Organisation intergouvernementale pour les transports internationaux ferroviaires
Zwischenstaatliche Organisation für den internationalen Eisenbahnverkehr
Intergovernmental Organisation for International Carriage by Rail

OTIF/RID/NOT/2017

Notification

1 January 2017 edition of RID

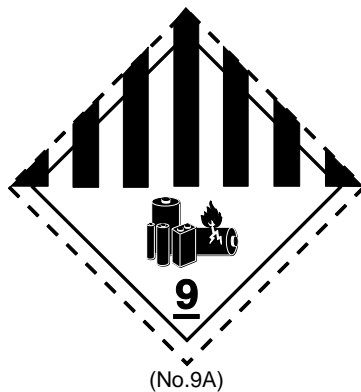
Replace "Figure 5.2.1.9.1.2" by:

"Figure 5.2.1.10.1.2".
